HISTORIC LANDMARK COMMISSION PERMITS IN NATIONAL REGISTER HISTORIC DISTRICTS JANUARY 25, 2016 NRD-2015-0129 Zilker Perk National Posister District

Zilker Park National Register District 10 ½ William Barton Drive

PROPOSAL

Build a new one story open air bath house near the Zilker Hillside Theater.

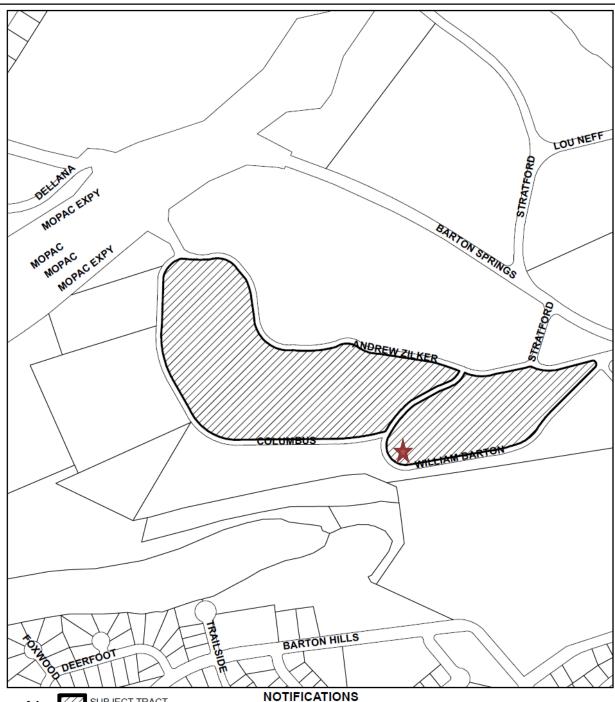
Build a one story open air bathhouse. The side wall of the bathhouse will be a natural cut (rough finish) limestone slabs on a slab concrete foundation. The concrete roof will be a slanted roof with the end closest to the ground facing the south. The roof will be supported by concrete round columns and will connect to the limestone walks with a decorated metal screen.

Release the application as proposed. The new bath house is near the Zilker bath houses; however its context is the Hillside Theater as well as the beginning of a trailhead. The bathhouse is a small one story building that takes its cues and materials from the natural setting of the park.
